ADDENDUM

PROJECT: University of South Dakota
Patterson Hall
Crystal Growth HVAC Package
Vermillion, South Dakota

AD-1

DATE ISSUED: Thursday, August 16, 2012

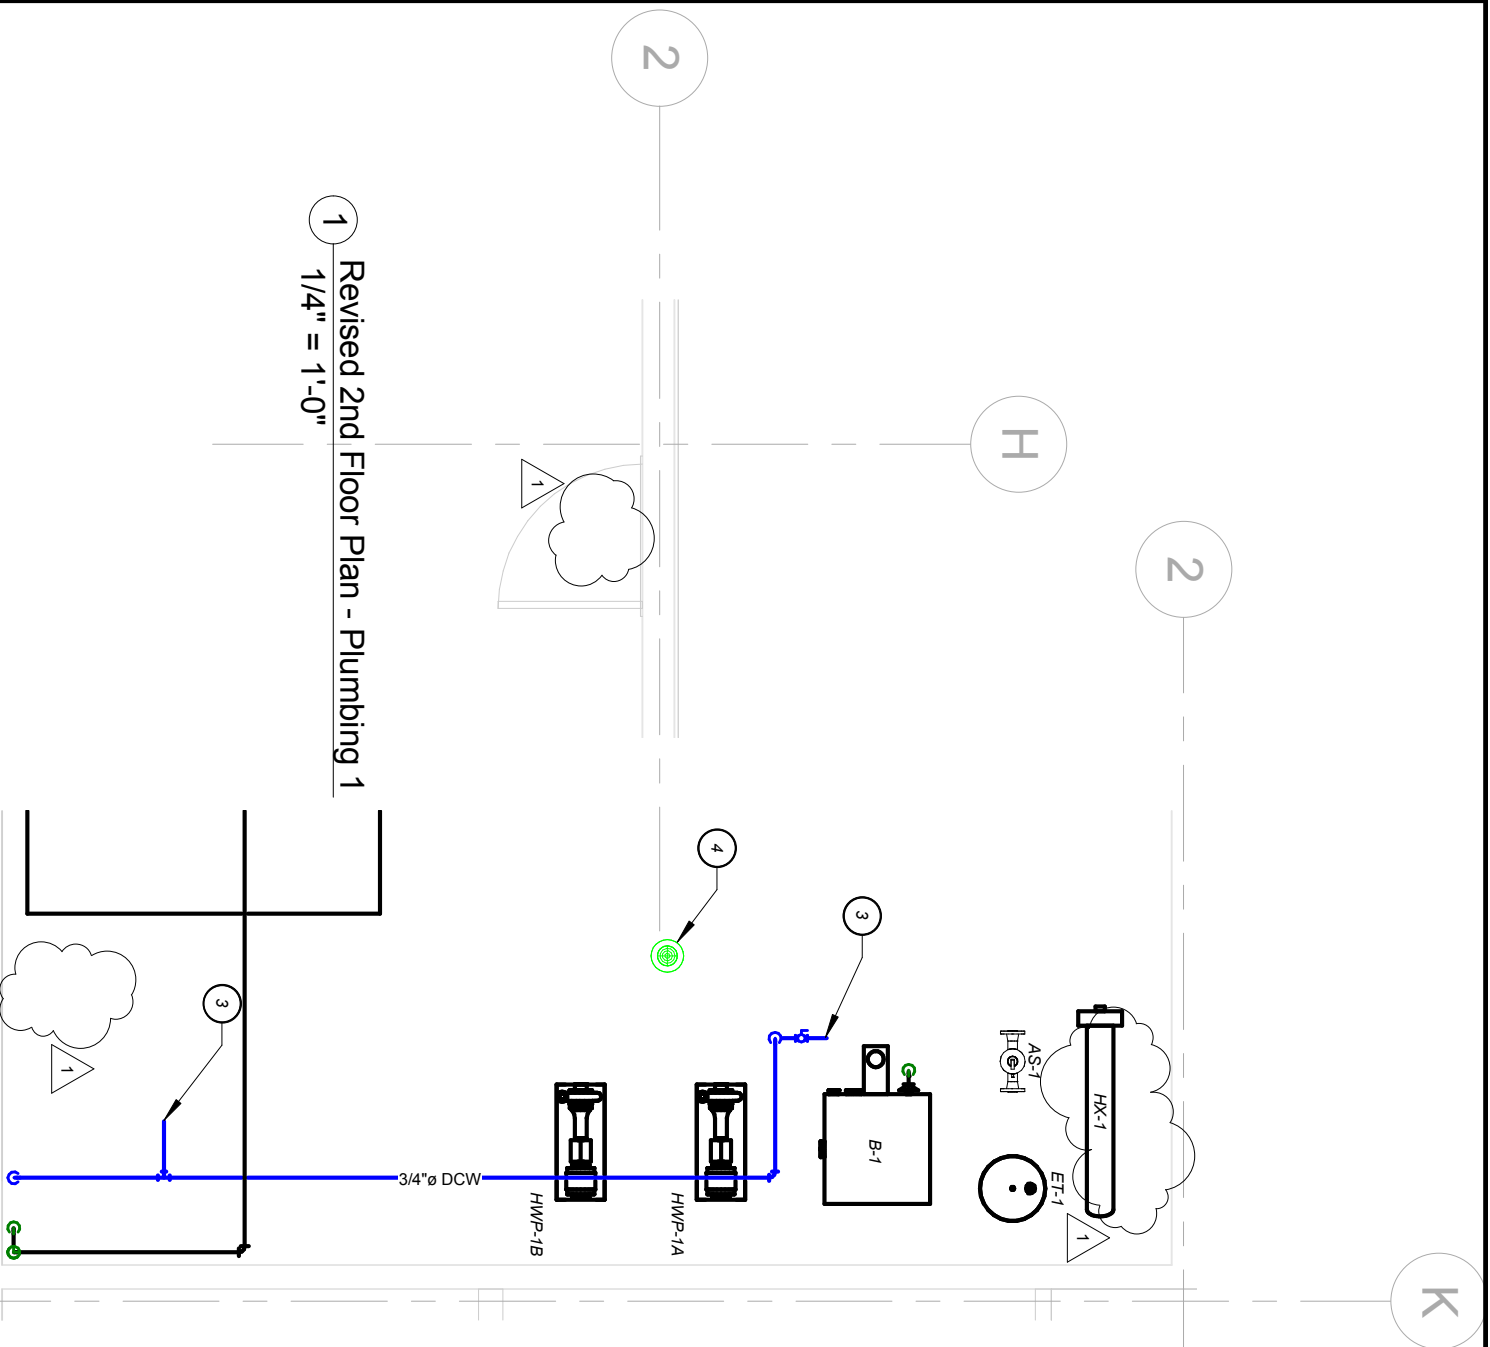
In reference to Sheet P-105 – HVAC Package Plumbing Plans, see attached supplemental Drawings P-105.1 and P-105.2 for modifications to the plumbing plans.
